1
2 **DOCUMENT 00 91 13**
3

8 ADDENDUM NO.1 Date: 08.02.21
9

10 RE: SAUK COUNTY COURTHOUSE AND HUMAN SERVICES BUILDING RENOVATIONS
11 515 OAK STREET, BARABOO, WI 53913 and
12 425 6TH STREET, REEDSBURG, WI 53959
13

2 MAIN LOBBY DEMOLITION PLAN - DUCT
SCALE: 1/4" = 1'-0"

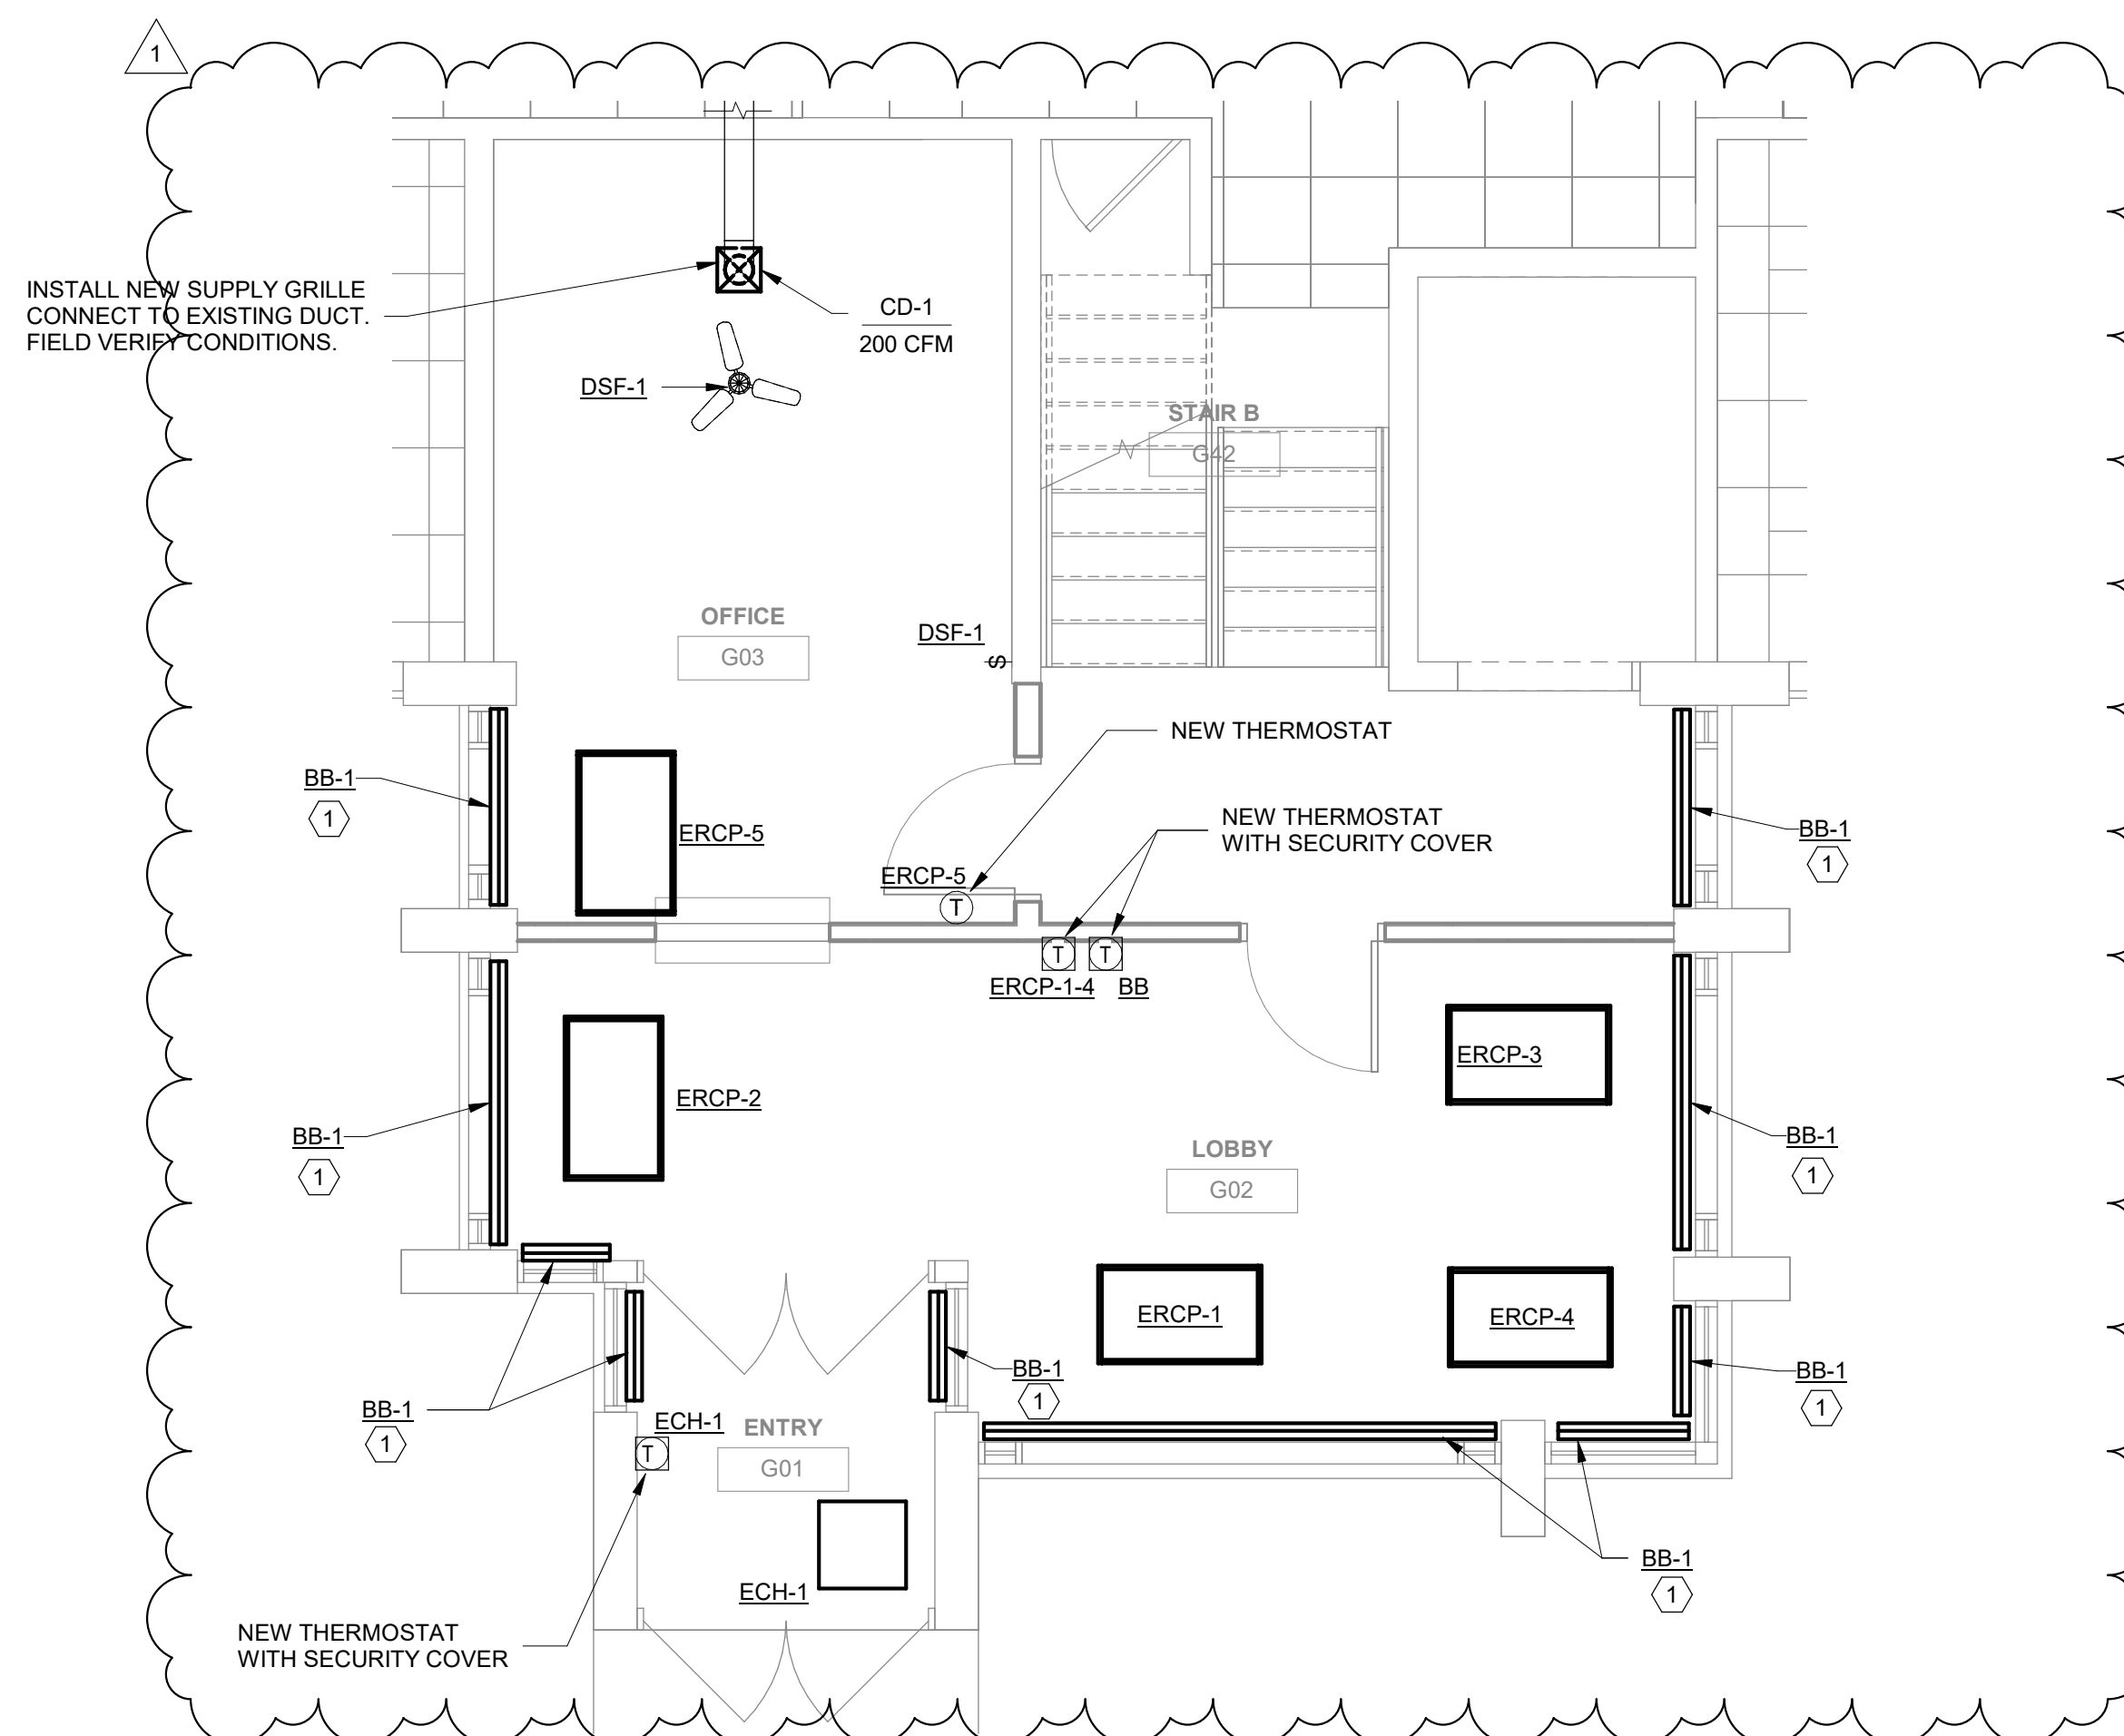
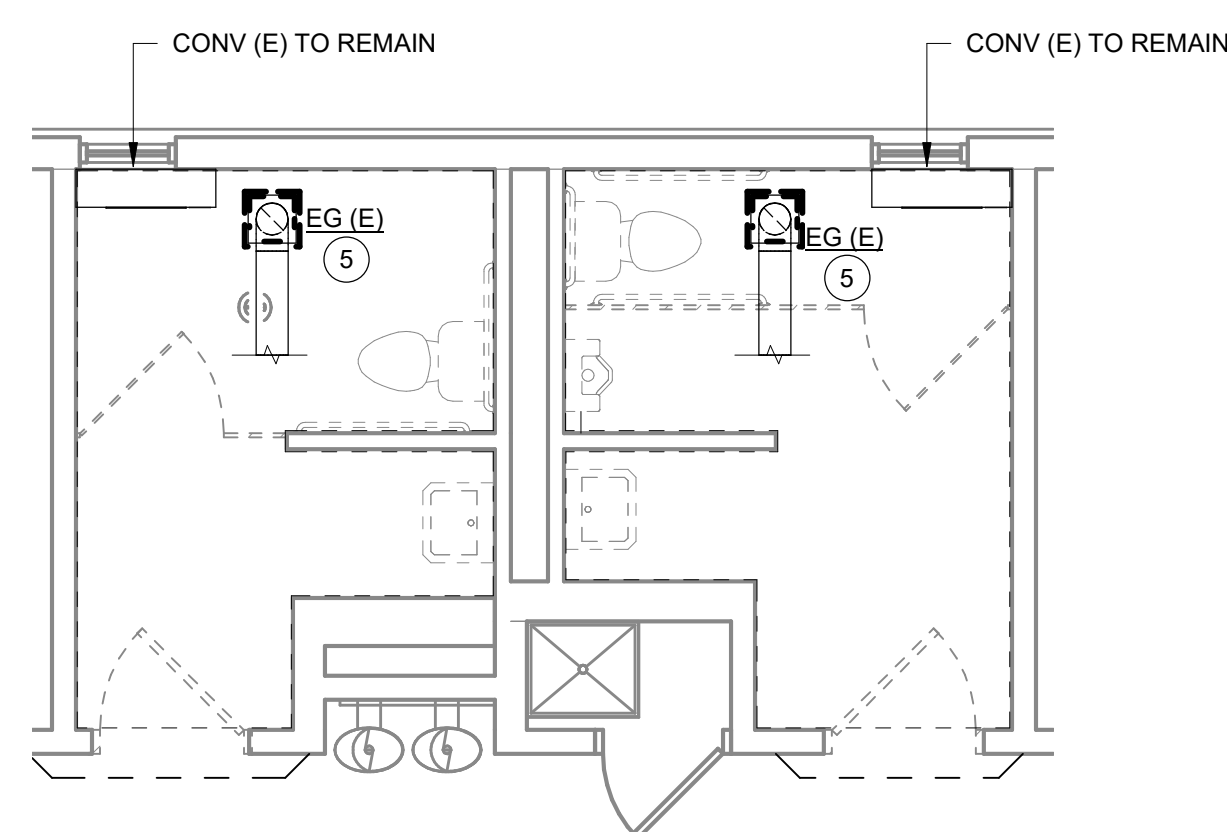
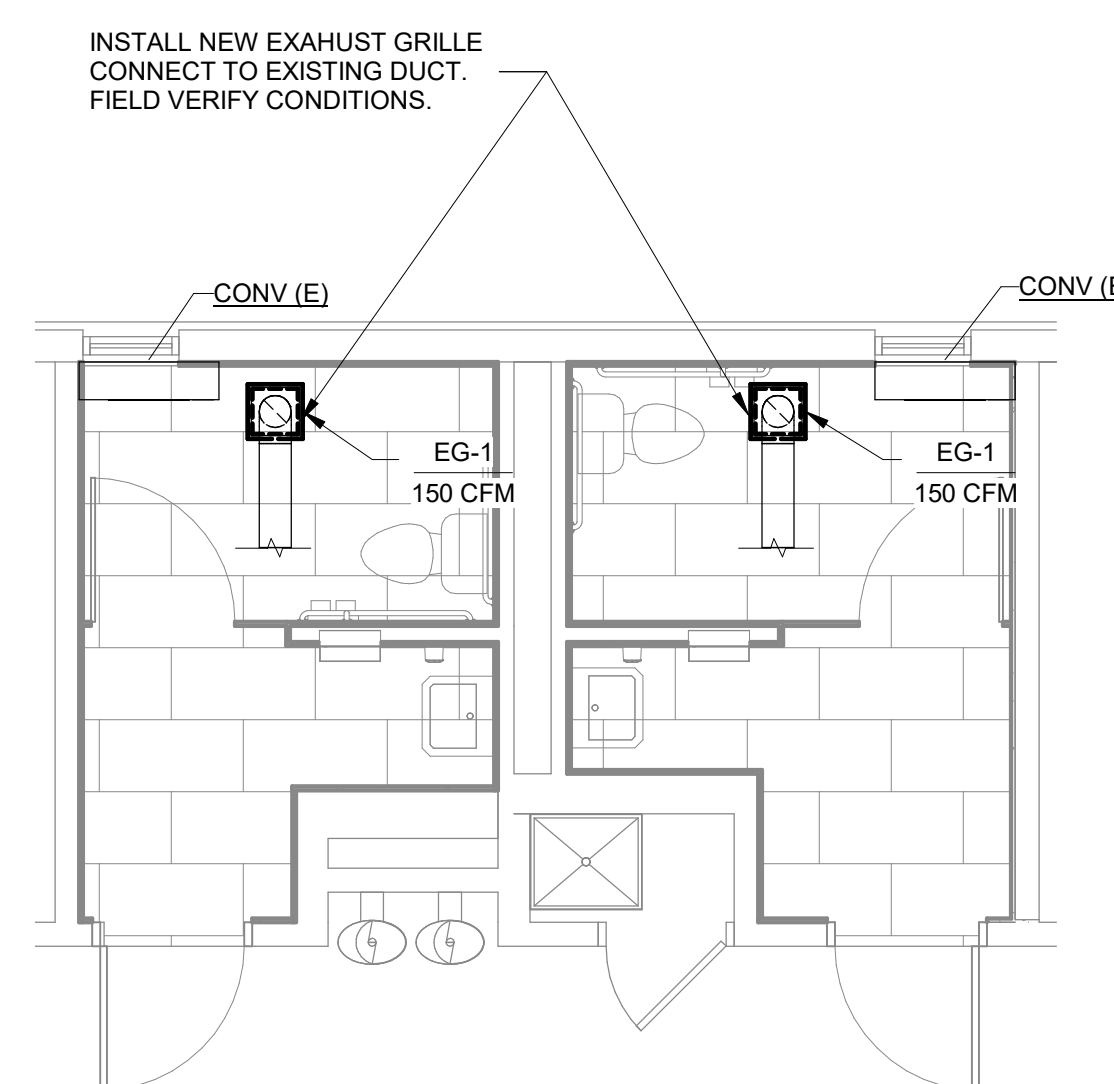
- 36
- 37 19. SHEET M101.2, FLOOR PLANS - DUCT
- 38 a. Replace sheet M101.2 in its entirety with attached M101.2
- 39 b. Add DSF control switch in Office G03.

- 40 c. Revised thermostat tags in Lobby G02.
- 41
- 42 20. SHEET M801.2, SCHEDULES & DETAILS - HVAC
- 43 a. Replace sheet M801.2 in its entirety with attached M801.2

DRAWING
SITE PLAN - ELECTRICAL

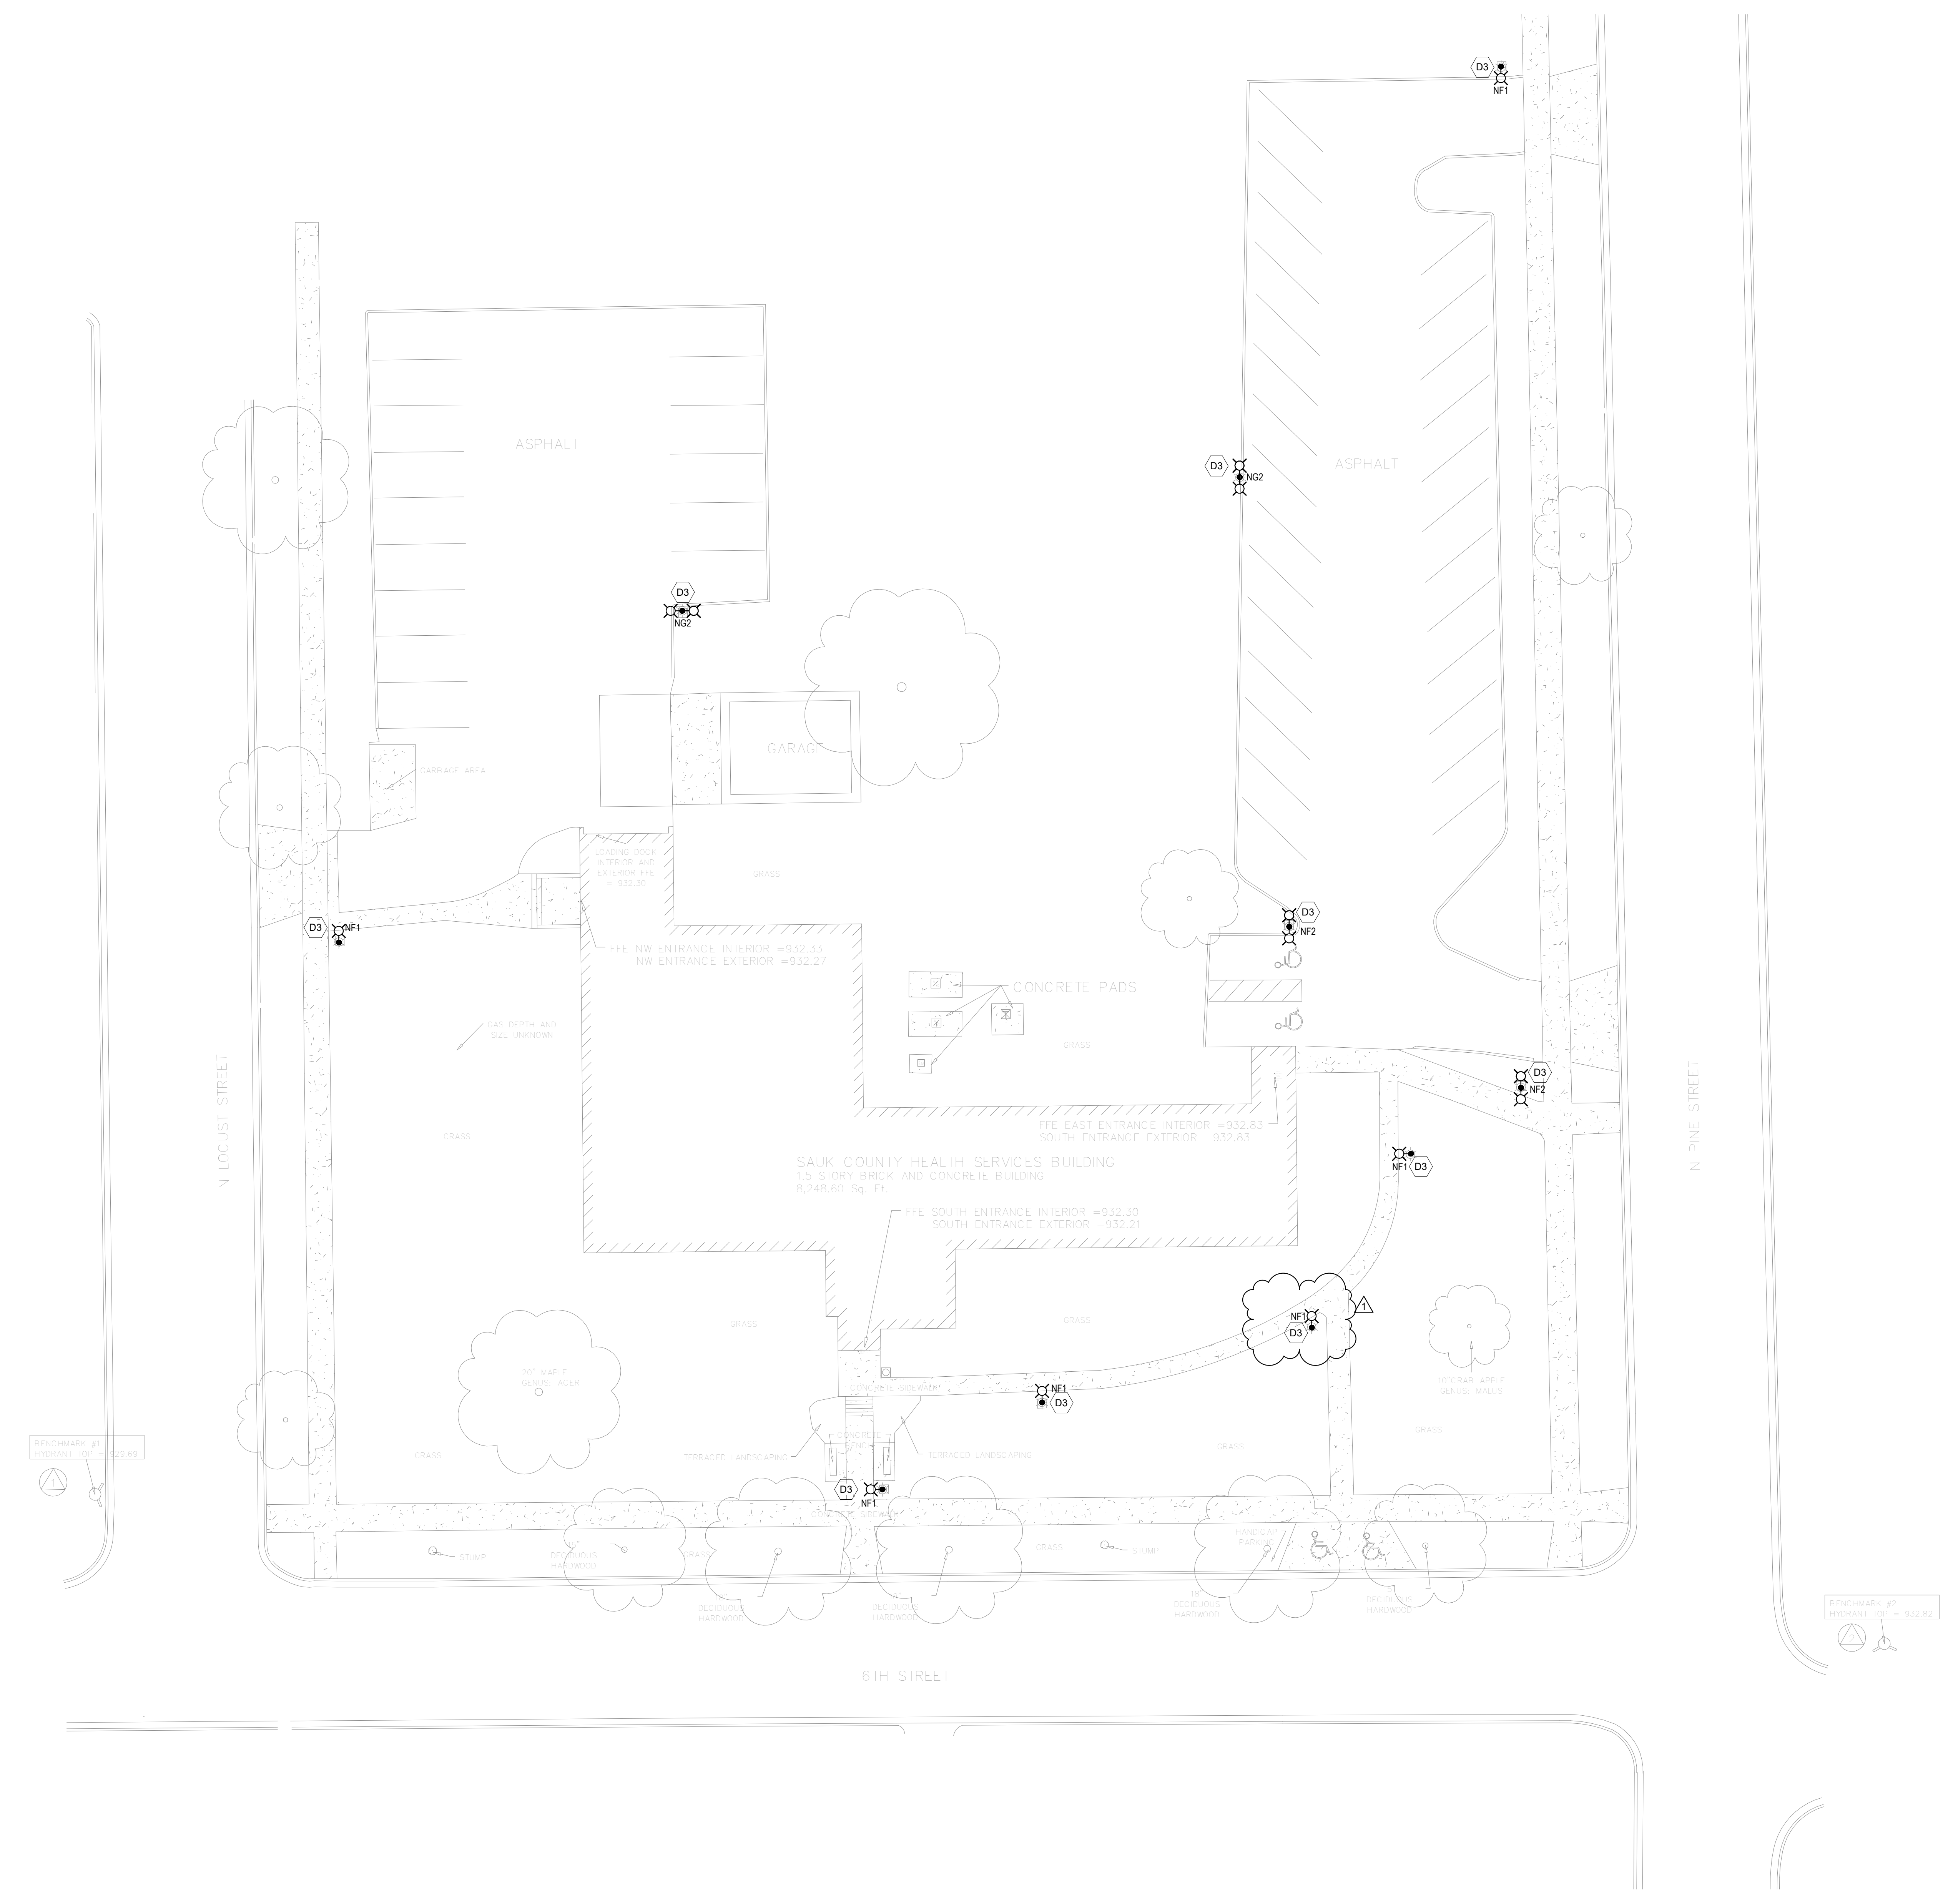
- 52 b. Revised orientation of (1) NF1 light fixture.
- 53 c. Revised General and Keyed notes.
- 54
- 55 23. SHEET E101.2, LOWER LEVEL DEMOLITION PLAN – LIGHTING
